Work Order ID 84439

Item Name: Replacement Skidtube

DRAWING NO. D2580	TITLE 205 SKIDTUBE ASSEMBLY	REV. E	DART AEROSPACE LTD ENGINEERING ORDER	D.E.O. NO. D2580-E-1	SHEET NO. SHEET 1 OF 1	SCALE NTS
DRAWN <i>UP</i>	CHECKED <i>ASS</i>	MFG. APPR. <i>ER</i>	APPROVED <i>[Signature]</i>	DE APPR. <i>[Signature]</i>		
DATE 11.12.13	DATE 11.12.13	DATE 11.12.13	DATE 11.12.13	DATE 11.12.13

CHANGE ALL C'BORED WELDED CROSSBOLT SPACERS TO SWAGED SPACERS

SECTION B-B, F-F, I-I
NOT TO SCALE

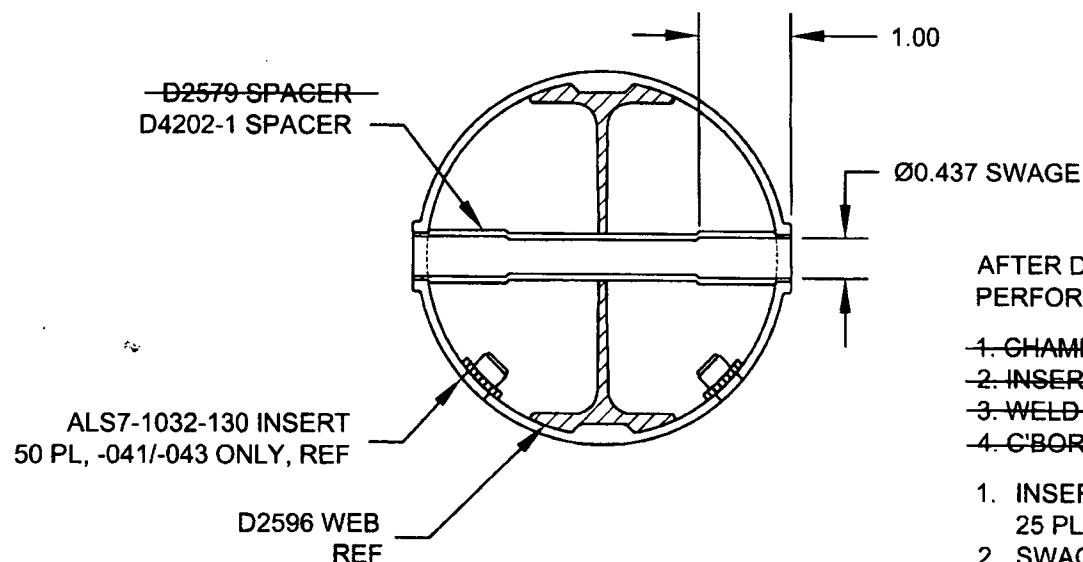
SECTION B-B, SECTION F-F, & SECTION I-I ARE AMENDED AS FOLLOWS
FOR ALL HOLES THAT WERE ORIGINALLY C'BORED:

1. CHAMFER HOLE 0.050 X 45°
2. INSERT D2579 SPACER (20 PLACES)
3. WELD INTO PLACE AND GRIND FLUSH
4. C'BORE D2579 SPACER TO Ø0.437 X 1.00 DEEP

1. INSERT D4202-1 SPACER, 20 PL (-041) OR 20 PL (-045) OR 25 PL (-047)
2. SWAGE TO Ø0.437 X 1.00 DEEP PER QSI 002
3. TRIM / GRIND FLUSH PER QSI 002
